OFFICER REPORT

Application Number	PL/2023/10723
Site Address	Tiryberth, Middleton Road, Winterslow, Salisbury. SP5 1PQ
Proposal	Demolish existing dwelling and construct new two storey 3 bedroom dwelling with new off-road parking.

Proposed Site Plan and Elevations:

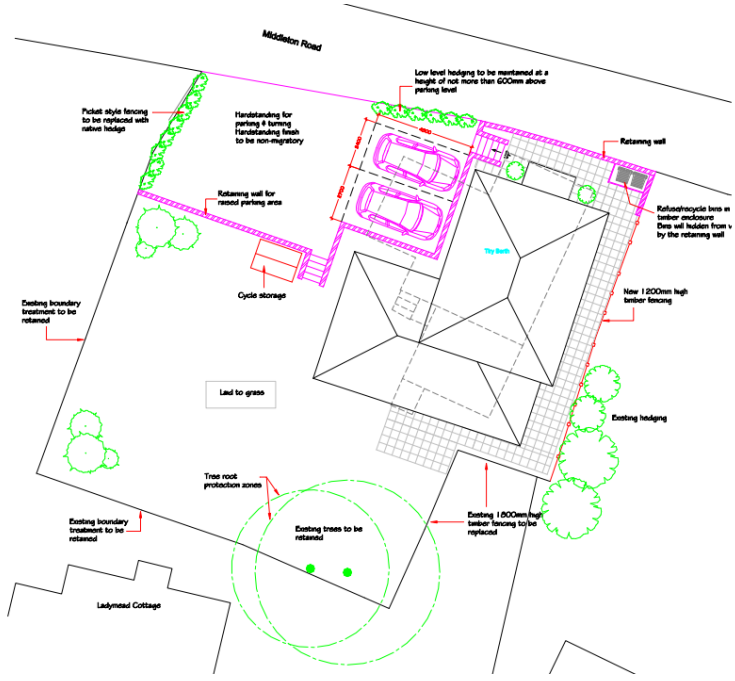
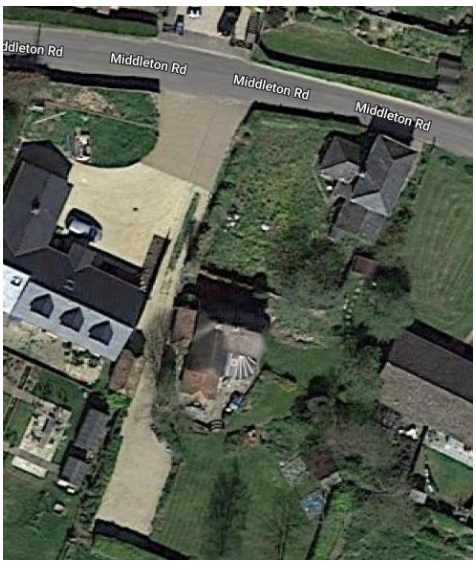
First of all, please note that the elevations on the plans are very faint and hard to see and that the new building will be 4 bedrooms, not 3.

We do not object to the principle of this application. However, please consider the following: The increased height and bulk of the new building, which will have moved from 2 beds to 4, will have an impact on the light levels and privacy of our home. We will move from having 1 window directly looking in to our home, to having 6 and much more of the morning light will be blocked. The proposed building looks very bulky and will be imposing alongside a thatched cottage and a bungalow. The visual impact of such a significant increase in size could be softened by not having one colour from floor to roof ridge such as red brick then clay tiles. Instead, a softer brick colour, rendering and a more natural-looking slate roof could all be considered. We are not clear about how the retaining wall for the parking will look. Please consider the impact on water flows when it rains heavily. Will what is currently earth/lawn, which soaks up some of the rain, become concrete because of the parking? Will what little garden is left have sheds placed on it? On Thursday 4th January 2024, several gardens in this section of Middleton Road were flooded because the existing drains could not cope with the degree of run off from the saturated land. Any non-porous materials, including in retaining wall foundations, will worsen this problem.

Although we have no objections to the proposed and the plot / surroundings would benefit from the demolish and construct of a new dwelling I would like the following to be considered. The existing South West elevation is in effect a single storey. With the increase to a two storey and increase in bulk of the proposed dwelling and extending towards our boundary this will have a real term imposing impact on Ladymead Cottage. This will also be the case with the proposed lounge on the North West elevation moving towards Ladymead Cottage.

It would be beneficial to understand more around the impact of the retaining wall and how this will be landscaped to hide the wall (Hedge, Sleepers etc).

Amended plans were received to reduce the bulk and scale of the dwelling and improve its detailing. Neighbours were re-consulted on 7/5/24. No further neighbour comments were received.

Then scheme has been reduced in design and scale since the application was first submitted. Officers are now content that the scale, detailing and appearance of the replacement dwelling would provide an enhancement to the streetscene and overall, it would enhance the character of the area given the dilapidated condition of the present house. The setting of the Grade II listed building is an important consideration for the proposal and the conservation officer has commented:

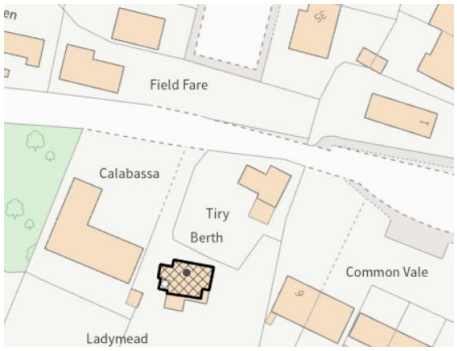
I am satisfied that this revision addresses my concerns adequately. The scale and proportions are much less dominant in the setting of the listed cottage, and subject to suitable slates and ridge tiles I am satisfied that the setting of the listed building would be preserved.

In conclusion, the scale, design. materials and siting for the replacement dwelling are considered to be acceptable and there would be no harm arising from the development on the character of the area, the setting of the listed building or the streetscene. The provision of off street parking for the dwelling would be a benefit of the development. No objection is raised under CP57, CP58, CP51 and C6 subject to suitable materials being agreed to suit the local vernacular.
